SR 25-14606-001 No Parking Sign Request - N Riverfront Drive/E Rock St.

Subject	Customer Service Request # 25-14606-001: Parking complaint
From	Blenfang, Cory
To	Maury Hooper
Sent	Tuesday, September 9, 2025 10:28 AM
Attachments	Image 1

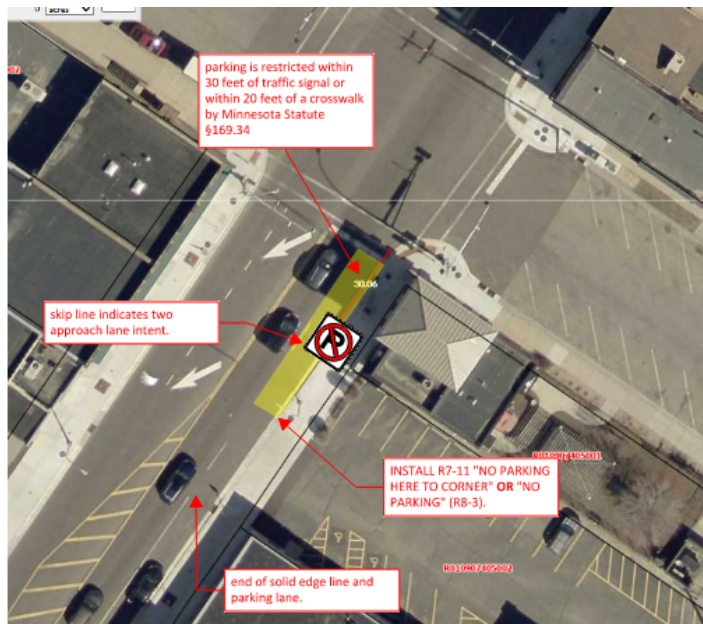
Installation of no parking signing is recommended for the segment between the access to Mom & Pop's parking lot and the crosswalk (identified by the yellow box in the image below). This would reinforce the intent of the in-place striping and align with Mn Statute that restricts parking with 30' of a traffic signal and 20 feet of a crosswalk.
